**CITY OF AUSTIN
APPLICATION TO BOARD OF ADJUSTMENT
GENERAL VARIANCE/PARKING VARIANCE**

STREET ADDRESS: 1900 W. 40TH STREET, AUSTIN, TEXAS 78731

CASE#: C15-2014-0090
 Address: 1900 W 40TH STREET

| PROJECT NAME: | BRADLEY RESIDENCE |

1 PROPOSED SITE PLAN + ADJACENCY MAP 1
NOT TO SCALE

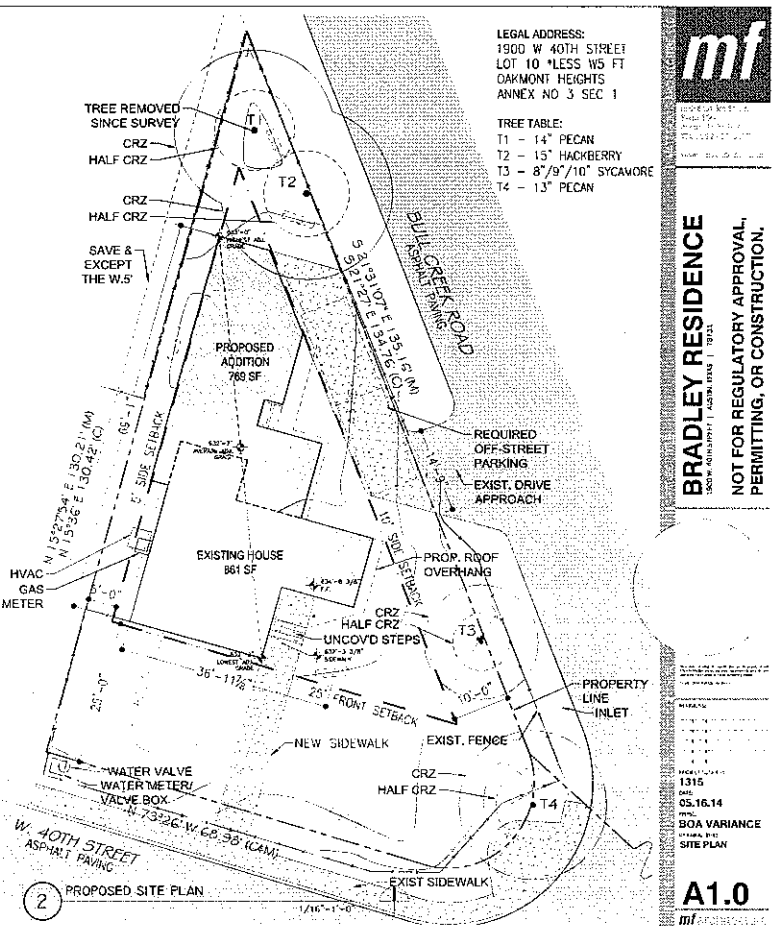
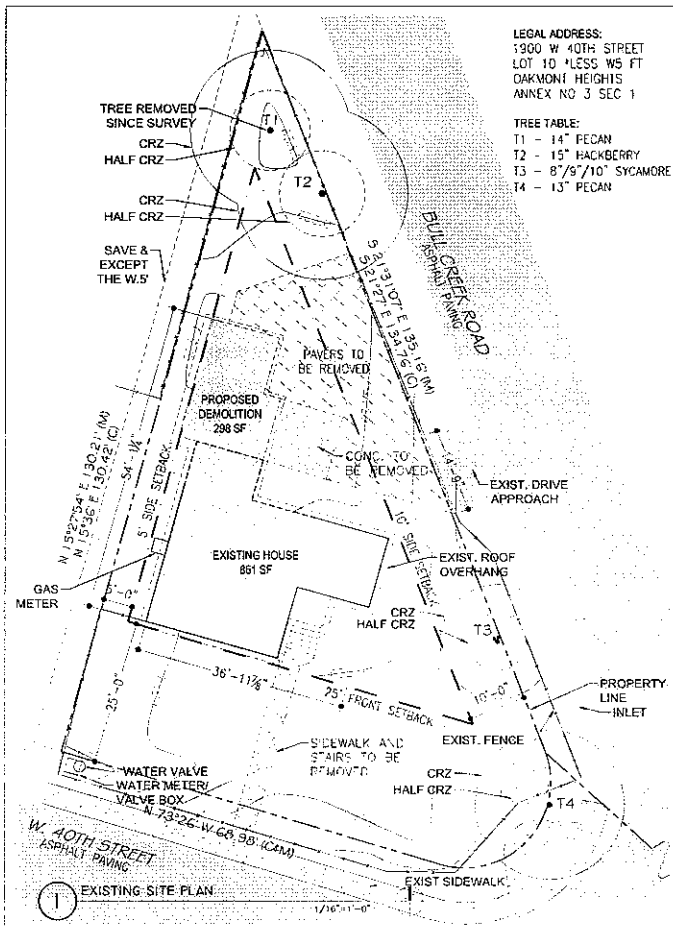
The 15' setback for SF3 does not allow for any reasonable addition to this property because of the unique shape of this lot. The existing house, which was exceptionally small at 861 SF, was built using the original 10' setback which allows for an appropriate addition to the property .

With the 15' side yard setback imposed on this lot, the corner/angled lot becomes virtually unusable beyond it's existing capacity. Lot configuration in this instance creates a unique hardship for this lot specifically.

A1.0

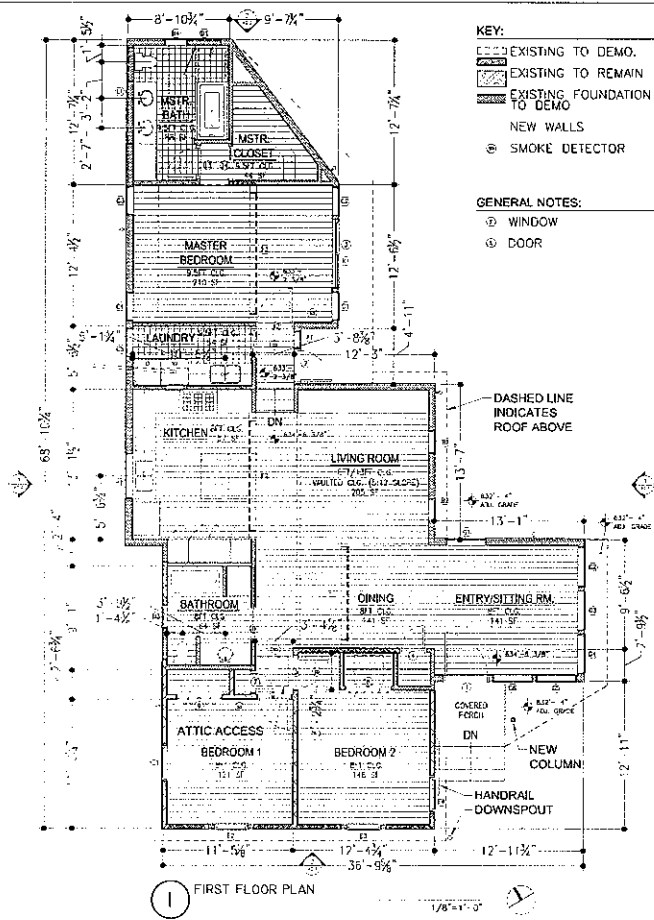
1. The home is a non-compliant structure and must meet Section 25-2-963 MODIFICATION AND MAINTENANCE OF NONCOMPLYING STRUCTURES. The current zoning setback requirements are; interior side yard is 5 ft., street side yard is 15 ft.

3. For new residential unit (house OR dwelling unit) OR an addition that increases the building GFA by 50%, the site is required to comply with the City's sidewalk ordinance. Please show the 4 ft.

sidewalk on Bull Creek Road and add per detail COA Standard No. 432S-1. LDC, Sec. 25-6-352-53; TCM, 4.2.1.

- a. The standard location for a sidewalk is between the curb line and property line, 2 feet off the property line. Show this dimension on the site plan. TCM, 4.2.1, 4.2.2.

Matt forwarded the message you sent on June 3 regarding the the 5' interior side yard setback. I've looked into this and it is **NOT** our intention to vary from this requirement. In my initial reading of Karen Palacio's comments I took the inclusion of this information as simply explaining the full scope of the setback requirements. Upon closer inspection, it looks like our plans *may* be encroaching into this setback by a couple of inches which is not intentional. I will contact Karen Palacios to see which she intended. If our plans do encroach on this setback, we will make the adjustments needed to comply.
